#20-03S – Special Permit – Garrett Homes, LLC

Location: 1600 Boston Turnpike (Assessor's map 10, Block 15, Lot 12B)

Intent: Construct 7,500 sf retail development

Subject: Proposed Retail Development  
1600 Boston Turnpike (Route 44)  
Town of Coventry

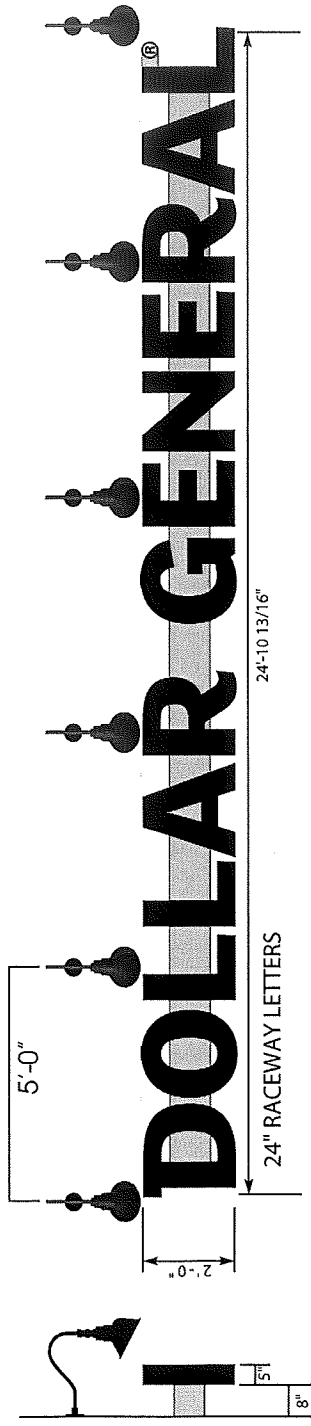
Attached sign – It was requested that the sign lettering be made black to match the detached sign. A revised rendering has been submitted which indicates this.

Customer: Dollar General	Description: M50 Custom Monument	
Project No: 433237	Scale: NTS	
Date: 7/10/20	Drawn By: DB	Revised:
Location & Site No: 1600 Boston Turnpike Coventry, CT	DG21414	Revised:

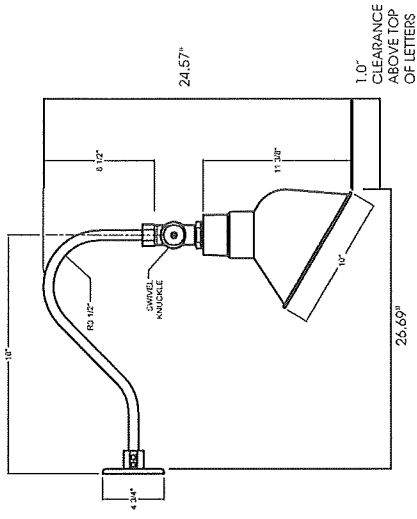
Detached sign – It was requested that the overall size of the sign face and structure be reduced to be closer to the scale of the Woodbury sign that was noted in an image that was shared with us. It is understood that the Woodbury sign did not have a structural frame like the one proposed for ours. Staff is concerned that the overall mass of the sign will be awkward in relation to the mass of the proposed building. The harmonious scale of the sign and building will improve the overall aesthetic of the site. The current sign proposal indicates that the overall sign/structure will be 80 s.f. in area. The sign face is proposed to be 50 s.f. in area. This matter is still in the process of being addressed.
